Design & Access Statement

Amendment Application

47 THE AVENUE, CLEVEDON

Image 4– Reduced ridge height - outline of planning consent shown with blue dashed line

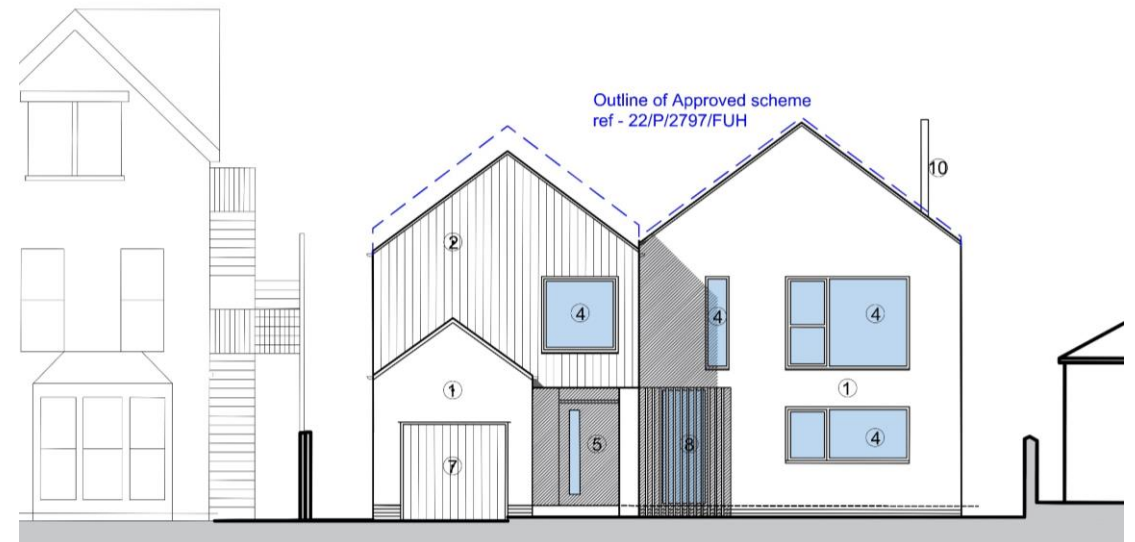
The ridge height has also been reduced (see image 4).

Image 1 – Side elevation, as viewed from no 49 site, with removed roof shown in red dashed line.

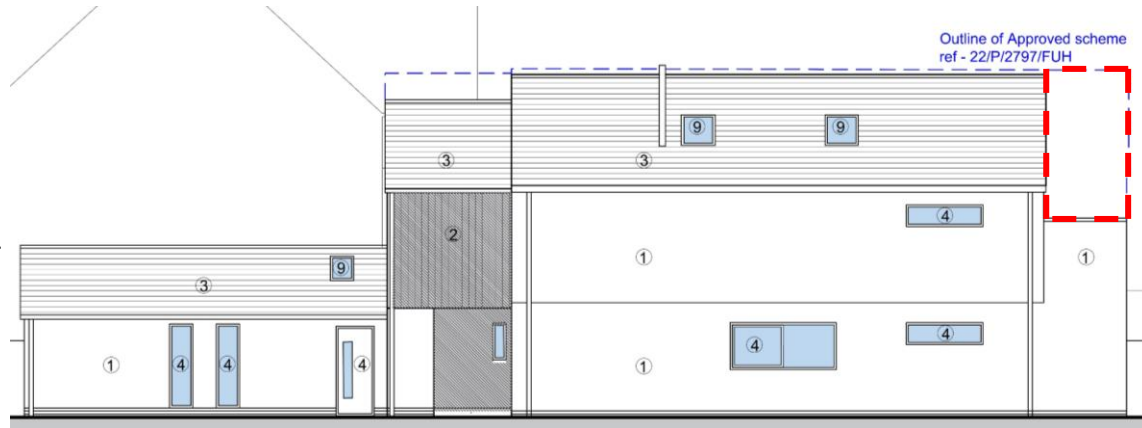
The roof over the rear balcony has been removed with the revised roof having the same footprint as the existing. This reduces the impact of the upper floor extension on the neighbouring house (no 49).

Image 3– Approved rear view with roof over balcony which is added to the rear of the original house

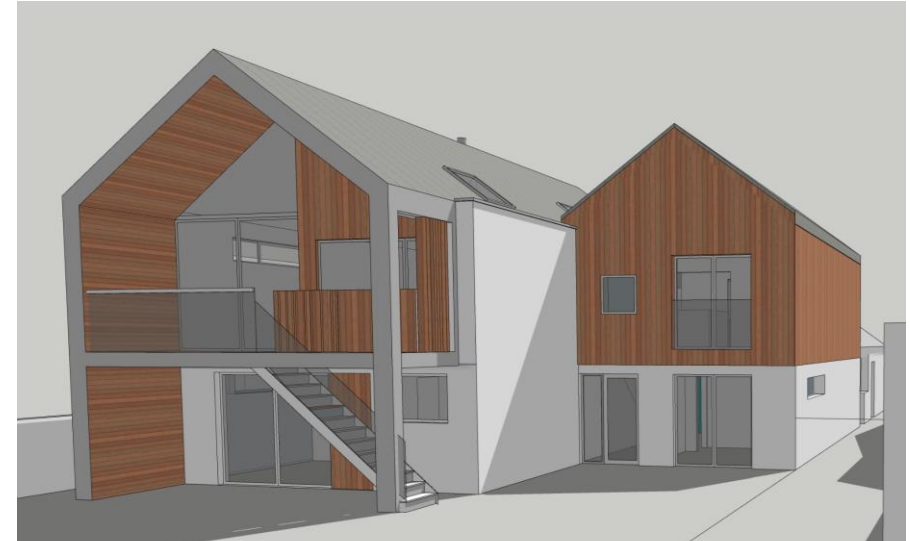
Image 4– Amended proposal with balcony roof cut back to the existing building line
